Brothers Fashion Ltd

Redwan Tower, Holding-1, , Block-B, Ward-15, Vogra, Gazipur.

16th October, 2016

Rebar mismatch on Ground Floor Column

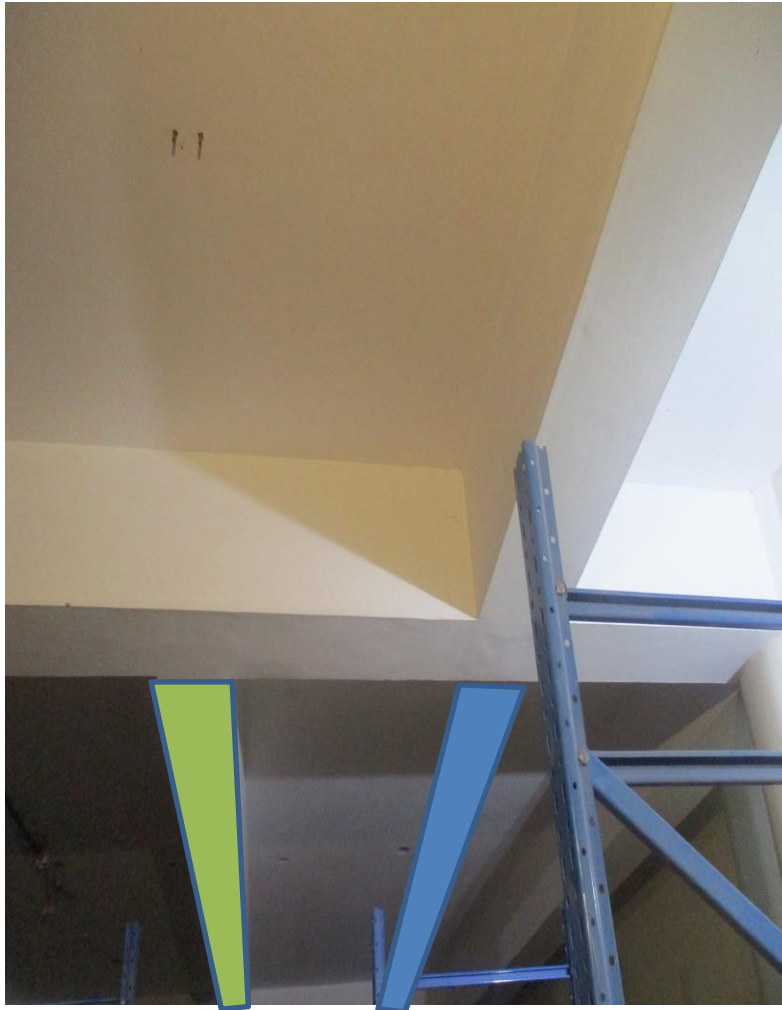
The Ferro scanning image shows that no of rebar doesn't match with the as built structural drawing.

Irregularities in Beam Layout

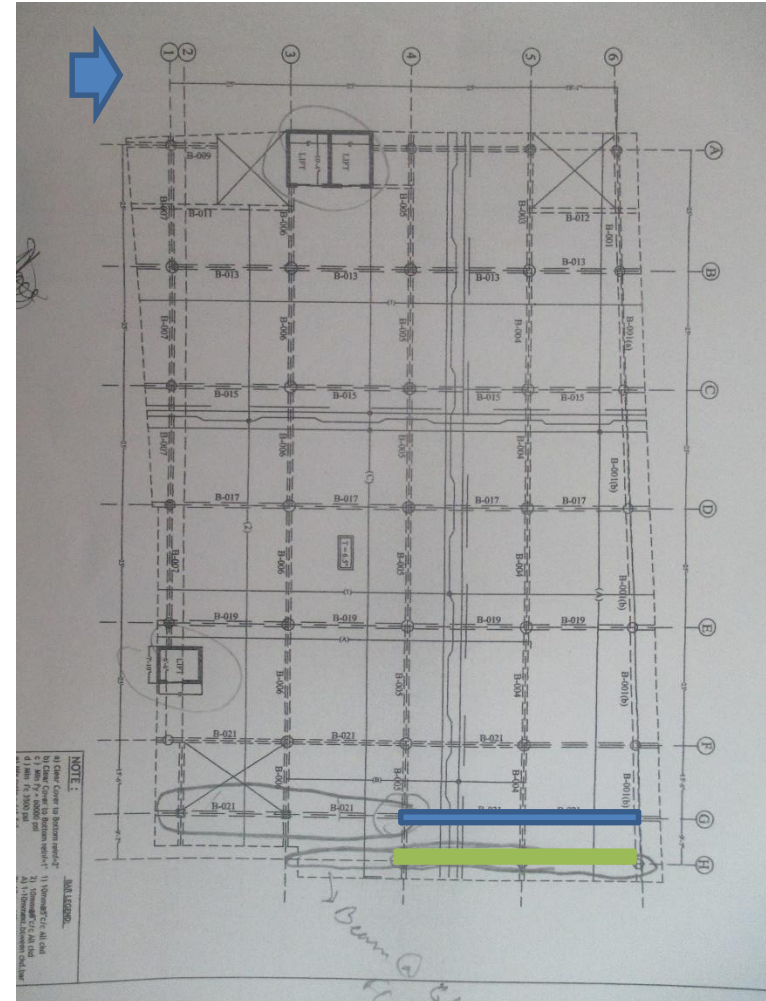
As per As-built drawing

On Site

Loads on Cantilever

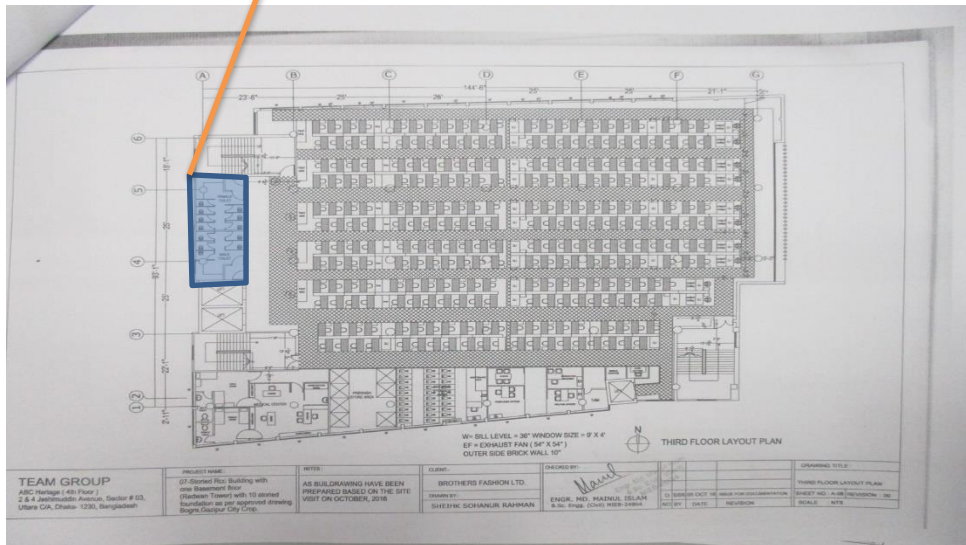
High Storage of Fabric has been observed on Cantilever Slab

Total with 150mm build up on cantilever slab

High Storage Load on Ground Floor

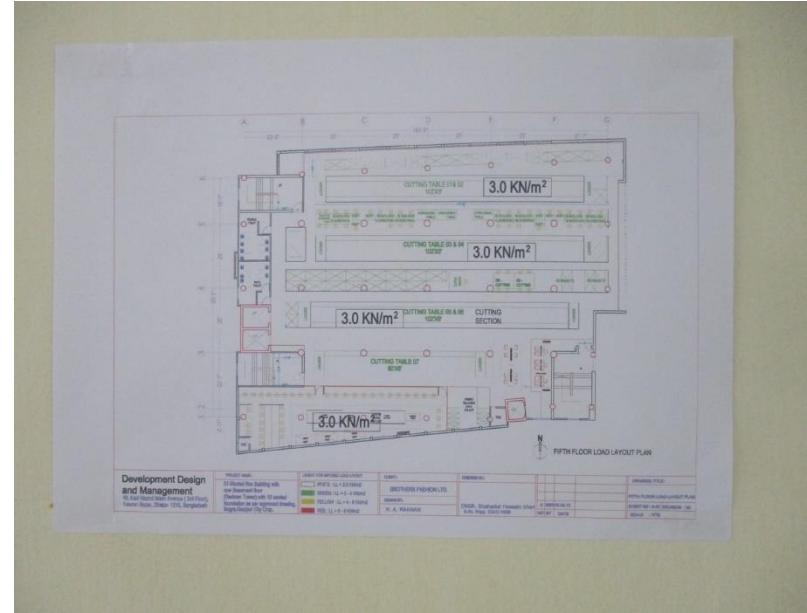
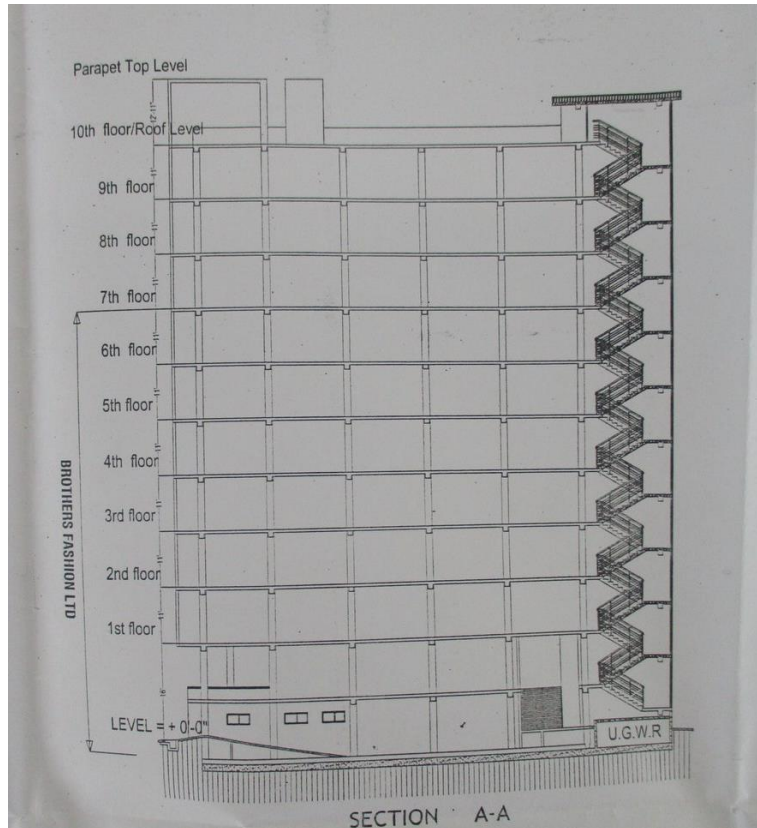
The Load Plan Posted on Ground Floor shows that allowable load limit is 3kn/m² but high storage load more than 3kn/m² has been observed on Ground floor

As built during inspection (8 story)

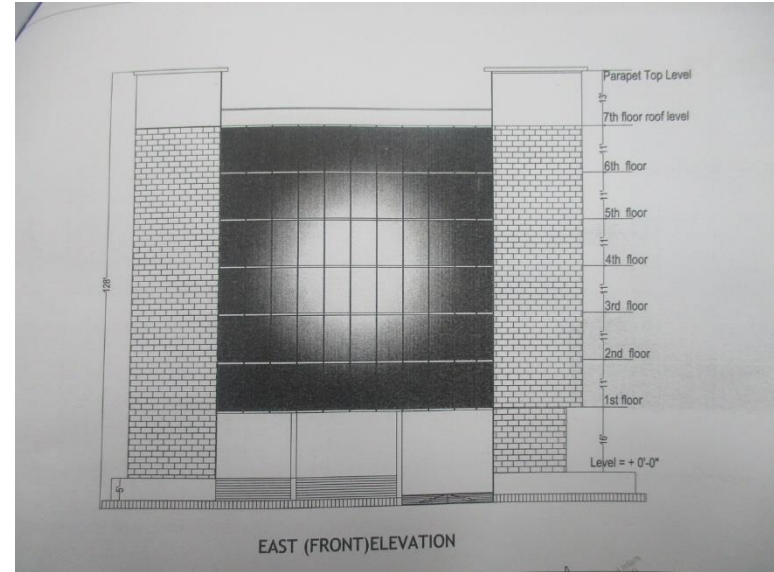
The building was permitted as 10-Storeyed building from local authority. During inspection, it was observed that the column was extending which shows sign of possible vertical extension in future. This vertical extension will cause high stress on columns.
